Detailed Review of FEMA CCAMP for City of Malibu

The City Of Malibu
23825 Stuart Ranch Road
Malibu, CA 90165

M&N File: 9937

Transect 8 (1116) Profile and Runup Parameters

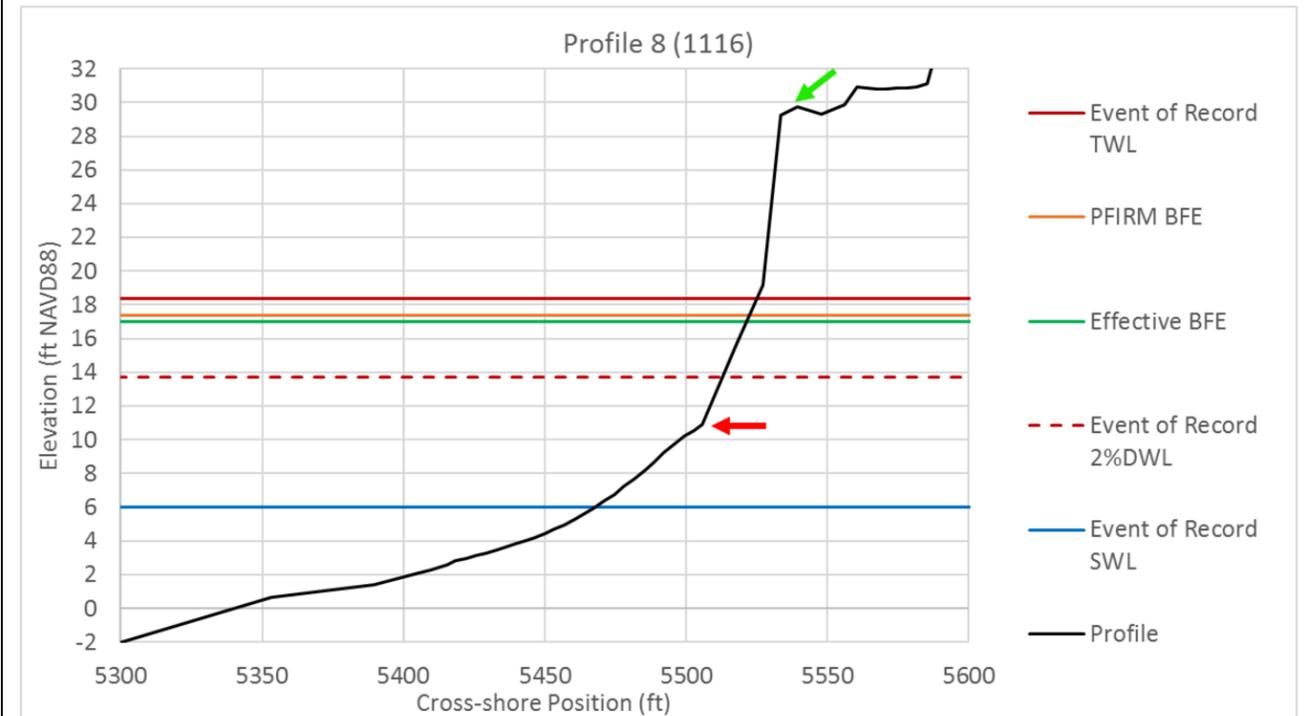
- ▶ BFE is 1 ft less than the event of record TWL.
- ▶ Mild beach slope with DWL2% above toe and $TWL_{TAW} > TWL_s$, therefore, TAW runup method is appropriate for event of record.

- Transect 9: 3/2/83 11:00, SWL = 5.4 ft, H_o = 16.2 ft, T_p = 15.9 sec, Toe el. = 11.8 ft
- ▶ BFEs are greater at upcoast and downcoast transects due to their steeper beach slopes and lower toe elevations. Transects 7 through 9 use the Stockdon Method for a majority of runup calculations, which is sensitive to increases in beach slope.

- ▶ Transects 7, 8, and 9 have similar wave exposure and shoreline features and should have similar BFEs.
- ▶ Coastal protection and structural design varies for each developed parcel.

The foreshore slope used in the Stockdon calculations is milder than the adjacent transects. If the foreshore slope becomes steeper, runup could increase to levels calculated at adjacent transects. At developed parcels the BFE will vary based on specific structural details. If the DIM Method were used, the BFE may be lowered by a few feet.

Transect 9 (1109) Profile and Runup Parameters

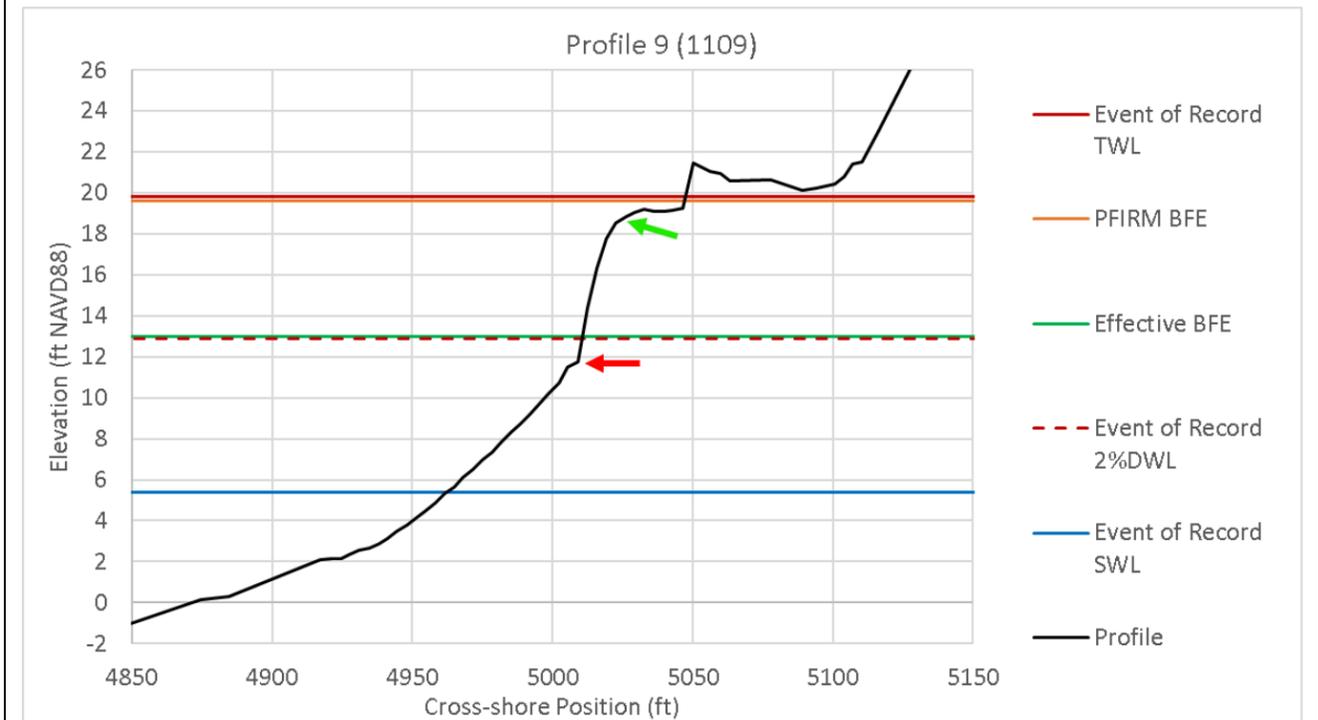
- ▶ BFE is similar to the event of record TWL.
- ▶ Mild beach slope with DWL2% above toe, but $TWL_s > TWL_{taw}$ therefore, Stockdon runup method is appropriate for event of record.

- ▶ BFEs for upcoast and downcoast transects:
 - Transect 8: 17 ft
 - Transect 10: 14 ft
- ▶ This transect uses the Stockdon method for all runup calculations similar to upcoast transects. The BFE is greater at this beach than Transect 8 because the slope used in the runup analysis is steeper.

The BFE is based on a wave encountering a sandy beach backed by a bluff. Variations in coastal protection and structures throughout this zone could influence the BFE for specific parcels in this zone. At developed parcels, the BFE will vary based on how waves interact with specific structural details at each parcel. If the DIM Method were used, the BFE may be lowered by a few feet.

Transect 11 (1091) Profile and Runup Parameters *INTACT CONDITION*

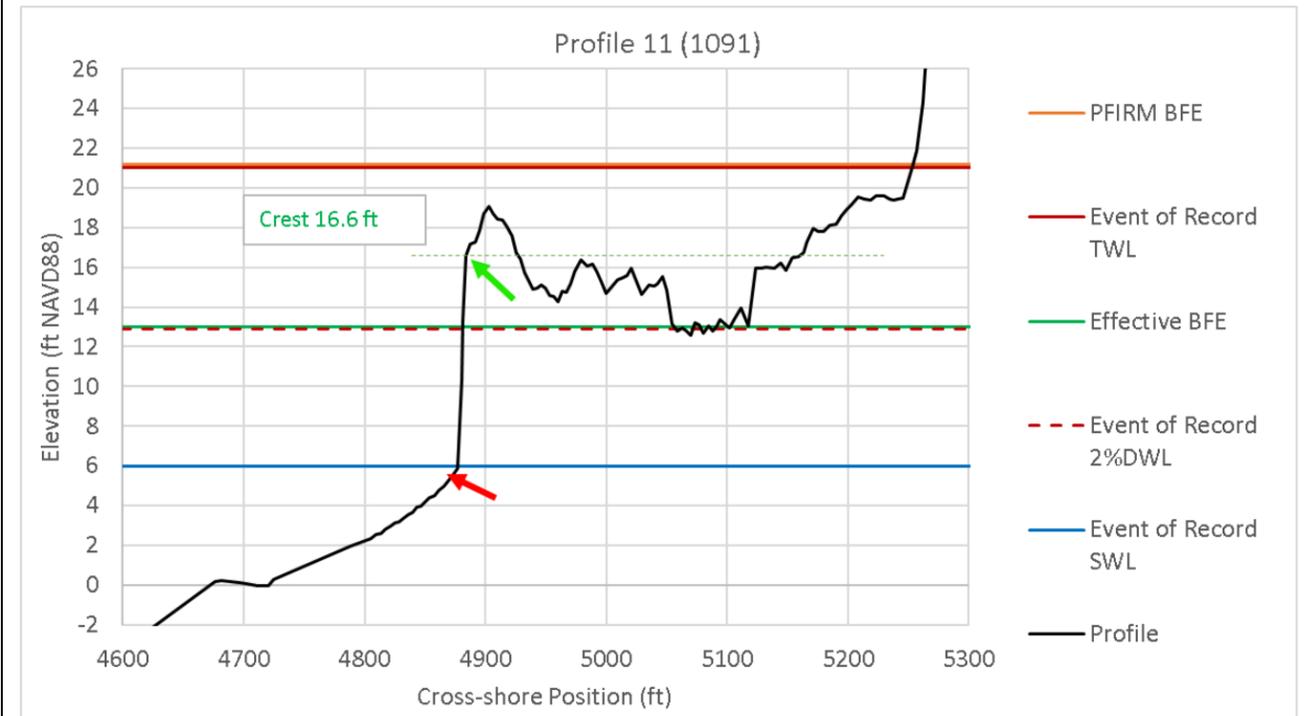
- ▶ The low toe elevation contributed to high BFE.
- ▶ Same roughness factor of 0.6 is used in both intact and failed condition analyses.
- ▶ Event of record parameters vary significantly from the upcoast and downcoast transects.
 - Transect 10: 1/27/83 7:00, SWL = 7.4 ft, H_o = 9.2 ft, T_p = 11.9 sec. Toe el. = 9.9 ft
 - Transect 12: 3/1/83 23:00, SWL = 6.0 ft, H_o = 17.2 ft, T_p = 15.9 sec, Toe el. = n/a
- ▶ BFEs for upcoast transects are expected to be less than Transect 11 due to sheltering and orientation upcoast and a wider, gently sloping beach downcoast.
 - Transect 10: 14 ft
 - Transect 12: 16 ft

The revetment along this reach is uniform and well-engineered. The intact treatment in the BFE calculations is reasonable. There may be an error in the BFE of secondary VE zone, which is 1 ft higher than the primary VE BFE.

Transect 20 (1008) Profile and Runup Parameters

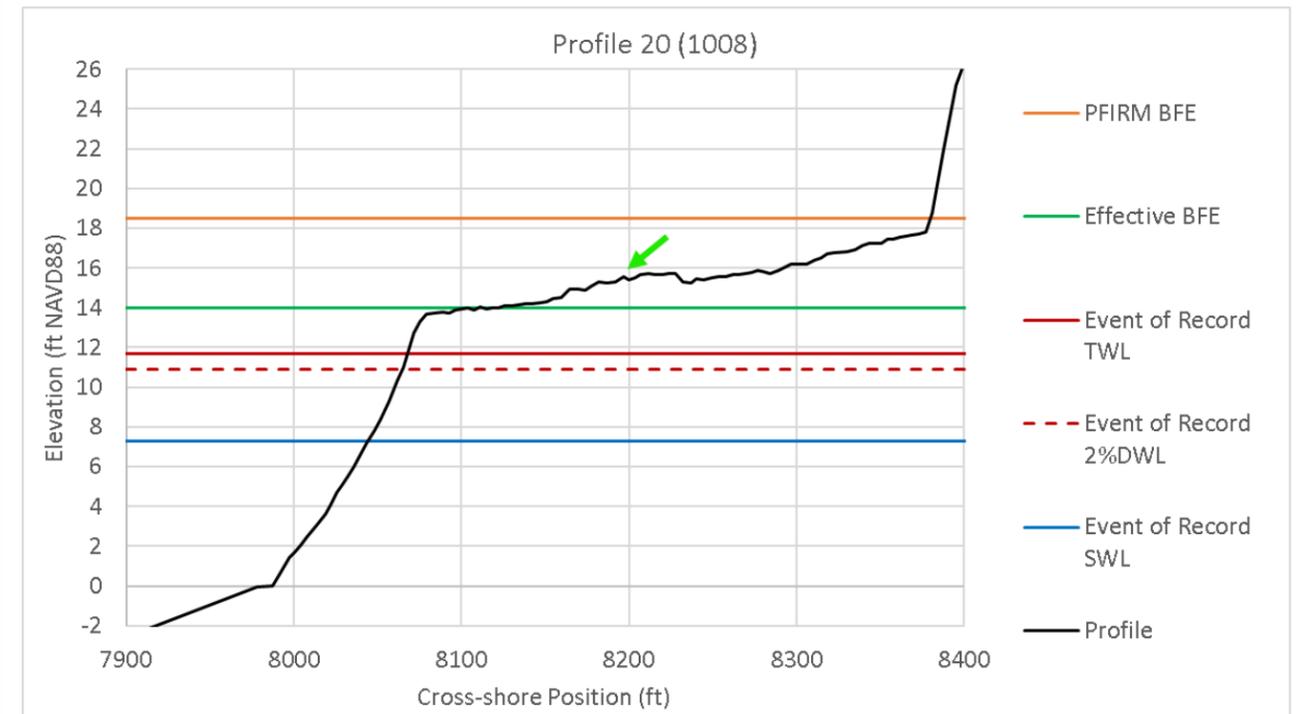
- ▶ There may be an error at the tie-in of the riverine and coastal flood zones. It appears that the Ramirez Canyon riverine BFE dictates the coastal Zone VE BFE. Although IDS4 states: "the coastal Zone VE BFE of 19 ft superseded the effective riverine mapping beyond the BFE 15 ft and 16 ft features and was tied into the 21 ft BFE." IDS3 detailed TWL results show that the TWL for the event of record is only 11.7 ft, similar to downcoast Transect 21, which has an event of record TWL of 11.7 ft and a BFE of 12 ft.

- Transect 21: 12 ft
- ▶ The coastal hazard Zone VE BFE should be similar to the downcoast transect as described above. However, the mapped BFE appears to be dictated by the riverine BFE.

The mapped coastal Zone VE BFE of 19 ft is not supported by the IDS3 detailed TWL results, which indicate the BFE in this zone may be closer to 12 ft. The Ramirez Canyon Riverine flood Zone BFE appears to dictate the coastal Zone VE BFE and the flood zone tie-in is unclear. An appeal may be warranted to determine if the coastal Zone VE BFE was mapped correctly.

Transect 25 (976) Profile and Runup Parameters

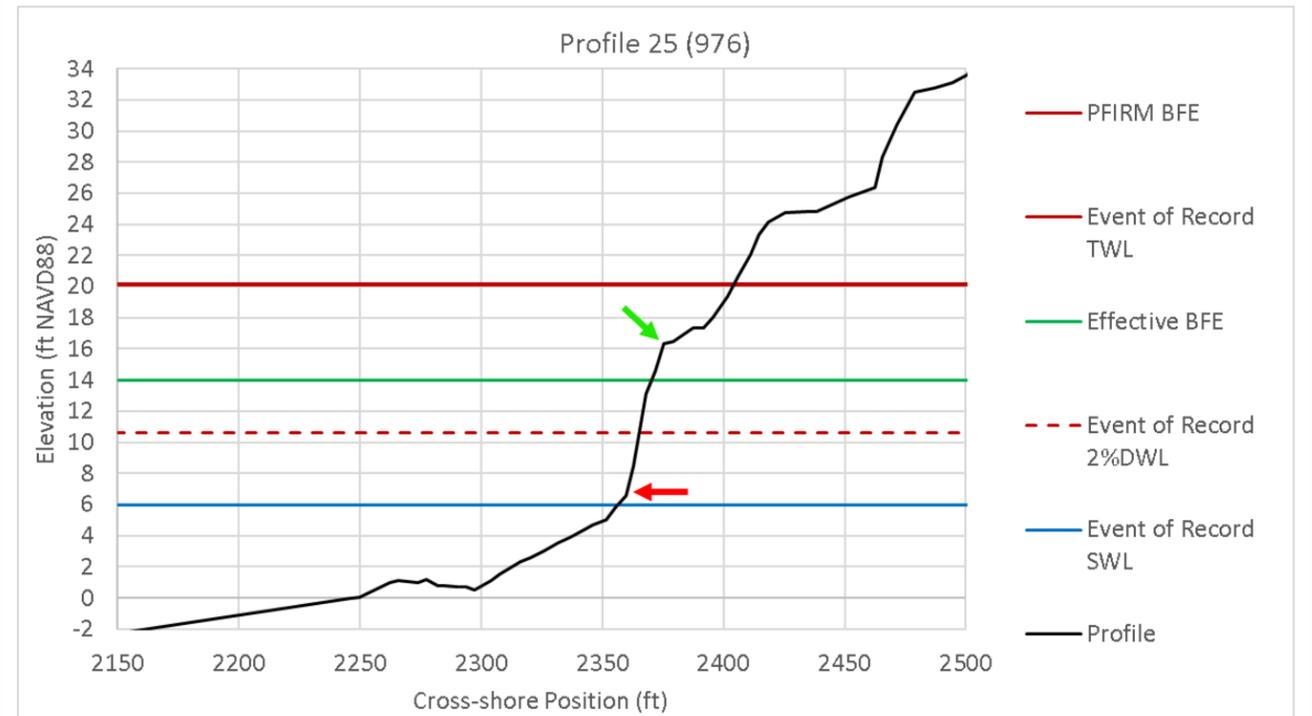
- ▶ Nearshore features like cobble, riprap, and the reef could potentially be considered for a reduction in BFE.

The BFE considers a wave encountering the bluff behind the residential beachfront parcels. Variations in coastal protection and structures throughout this zone could influence the BFE for specific parcels in this zone. If a slope roughness coefficient and oblique wave angle reduction factor were applied, the BFE would be lowered by several feet.

Transect 28 (946) Profile and Runup Parameters

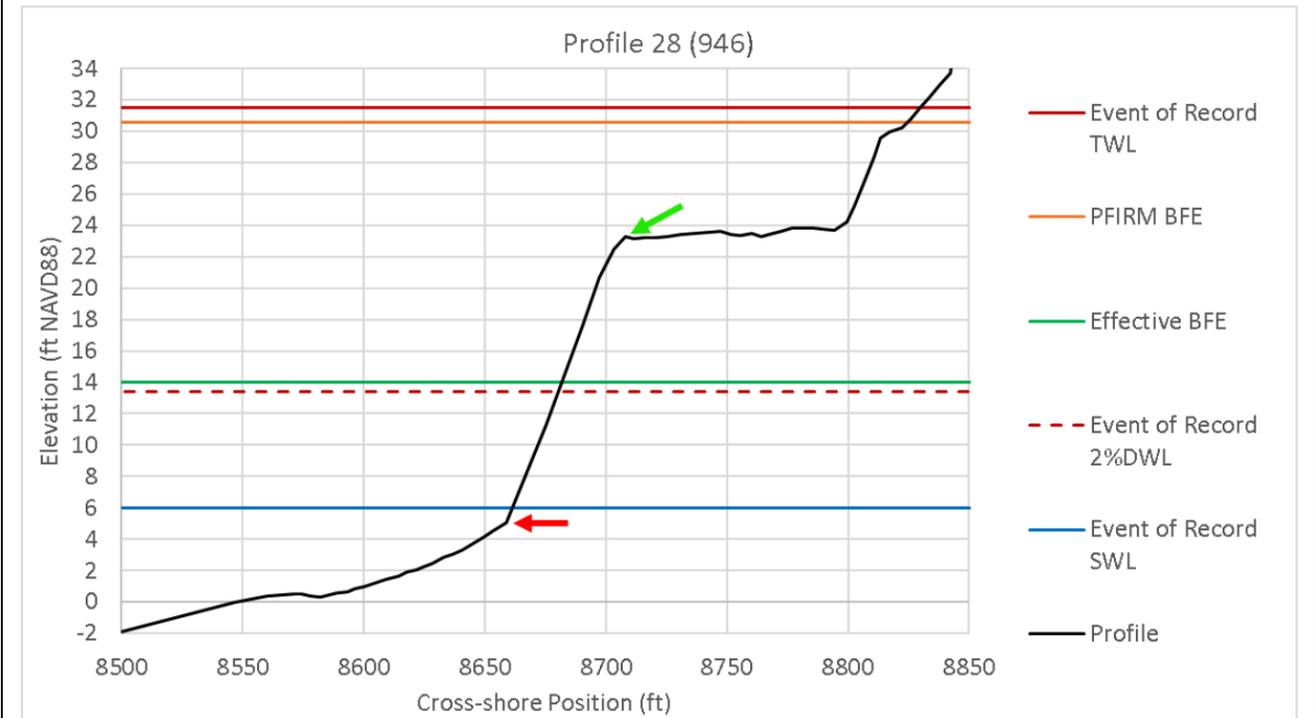
- ▶ BFEs for upcoast and downcoast transects:
 - Transect 27: 20 ft; Transect 29: 16 ft
- ▶ The toe elevation seems low, especially compared to the adjacent transects with similar shore types.

The BFE in this zone may be overestimated. The bluff characterization at this transect is not representative of the overall zone. The low toe elevation results in TWL calculations assuming waves encounter the steep bluff slope. An appeal may be warranted to select a transect that is more representative of the zone. A higher bluff toe elevation would result in lower TWLs and a lower BFE. Variations in coastal protection and structures throughout this zone could influence the BFE for specific parcels in this zone. The BFE may be lowered by a few feet if a roughness factor were considered.

Transect 32 (906) Profile and Runup Parameters

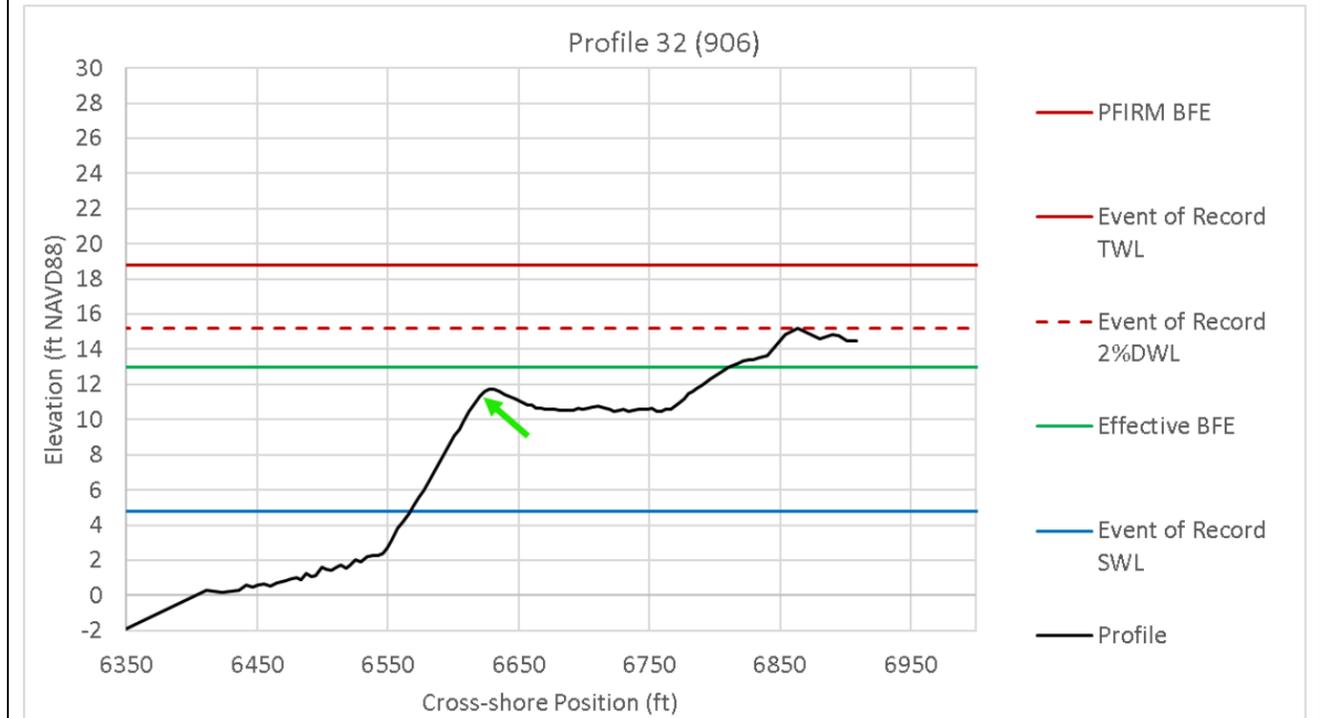
- ▶ BFE is similar to event of record TWL.
- ▶ DWL2% exceeds beach crest for event of record (assumes the wave is breaking beyond crest).
- ▶ Event of record parameters vary from upcoast and downcoast transects due to differences in shore orientation and exposure.
 - Transect 31: 3/2/83 11:00, SWL = 5.4 ft, H_o = 14.2 ft, T_p = 15.9 sec. Toe el. = 15.9 ft
 - Transect 33: 1/29/83 9:00, SWL = 4.8 ft, H_o = 6.8 ft, T_p = 15.9 sec, Toe el. = 11.9 ft
- ▶ The downcoast transect BFE is lower due to differences in orientation, exposure, and shoreline type; although these type of differences also exist at the upcoast transect, the BFE is similar.
 - Transect 31: 19 ft
 - Transect 33: 13 ft

The transect is not representative of the west zone with structures. The backshore seawalls and other structural elements were not factored into the runup analysis and floodplain mapping. Also, if the DIM Method were used instead of Stockdon, the BFE would be several feet lower.

Transect 33 (894) Profile and Runup Parameters

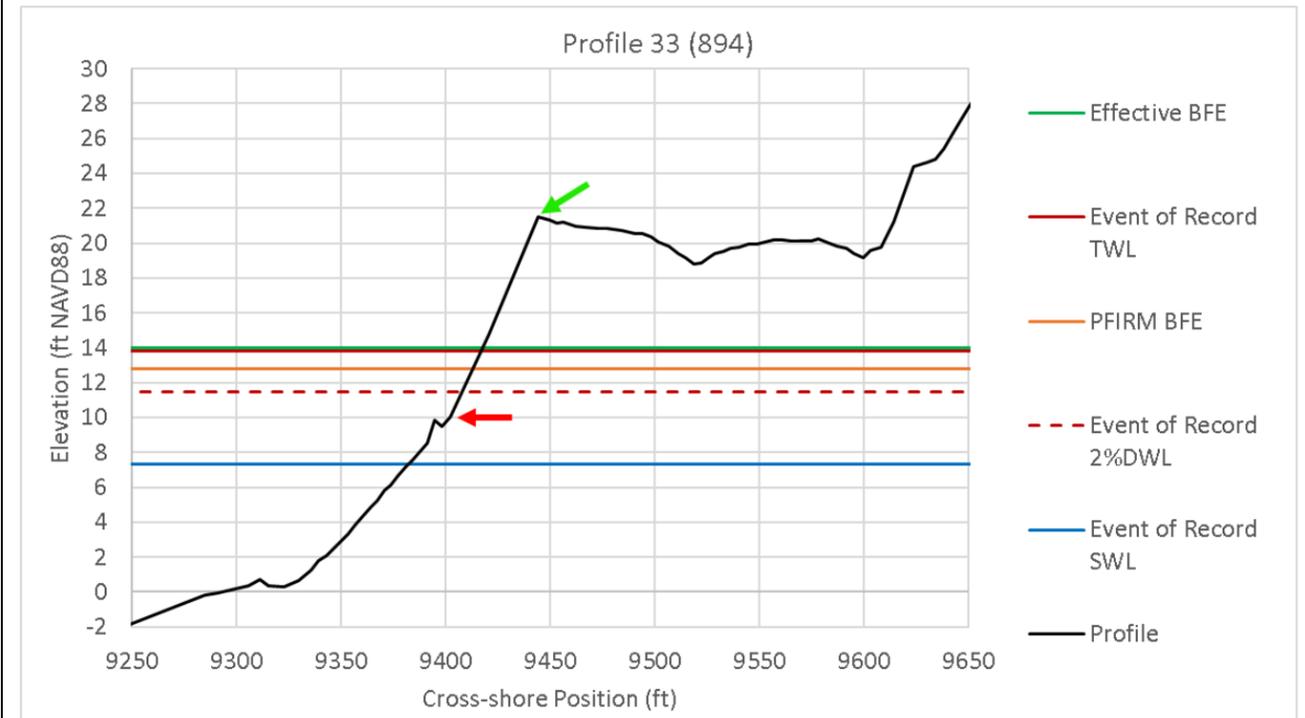
- ▶ Although the upcoast and downcoast transects have different shoreline characteristics, this transect is significantly lower than both. This may also be due to the differences in slope calculation between runup methods, IDS3 detailed TWL results show a difference of 4 ft between the Stockdon and DIM Methods at transect 34.

- ▶ DIM slope values range from (H:V) 7.4 : 1 to 53.2 - 1
- ▶ The large variation between transect 32 through 34 is strange, longer term beach slope data and revised wave runup methods should be considered. If these large differences in BFE do exist, a transition zone could be included.

The BFE is lower in this zone due to the runup methodology used. Bounding transects were evaluated with the Stockdon Method and have a higher BFE. Comparing IDS3 detailed TWL results shows that the event of record at transect 34 has a TWL of 16.7 ft for Stockdon and 12.5 ft for DIM.

Transect 34 (885) Profile and Runup Parameters

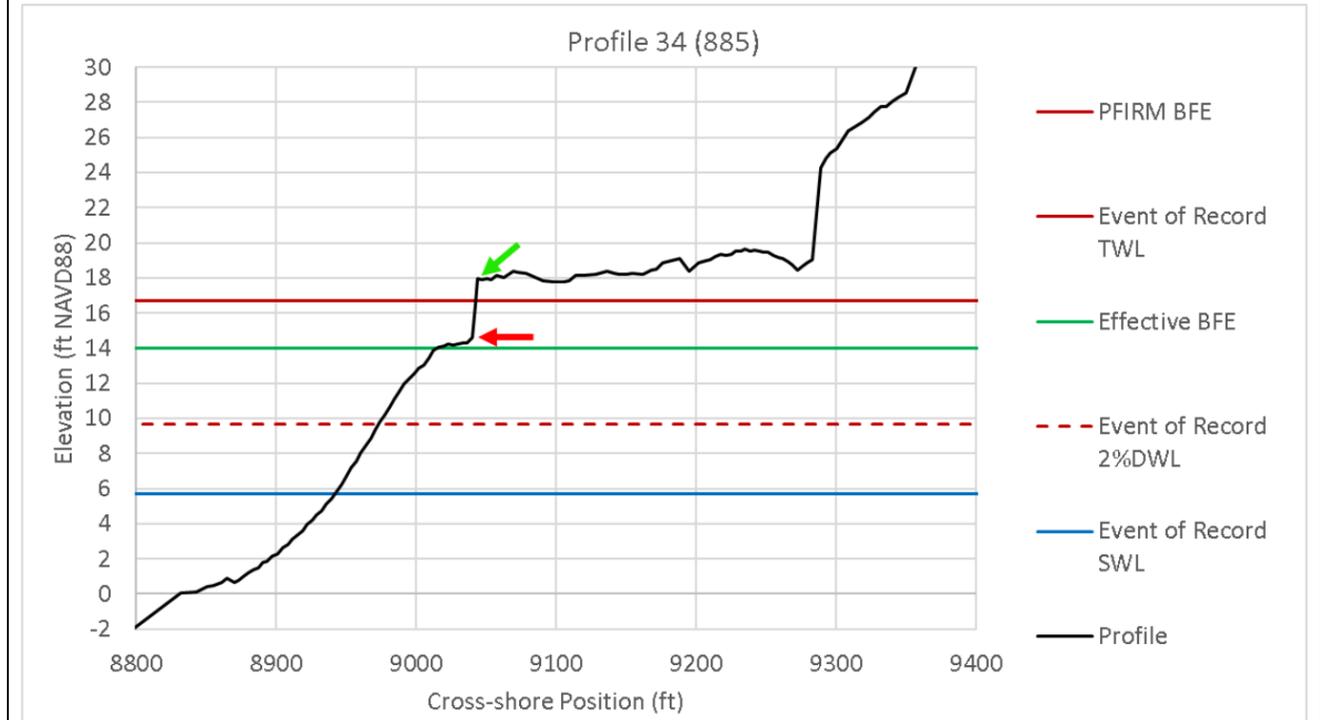
- ▶ BFE is similar to event of record TWL.
- ▶ IDS3 detailed TWL results show the event of record has a TWL of 16.7 ft for Stockdon compared to 12.5 ft for DIM. Wave input parameters may not adequately characterize reduced nearshore wave heights due to oblique approach angles and influence of nearshore bathymetric features.

The BFE is based on a wave encountering a sandy beach that slopes up to PCH. Variations in coastal protection and structures throughout this zone could influence the BFE for specific parcels in this zone. If the DIM Method were used instead of Stockdon, the BFE would be several feet lower, similar to the upcoast transect.
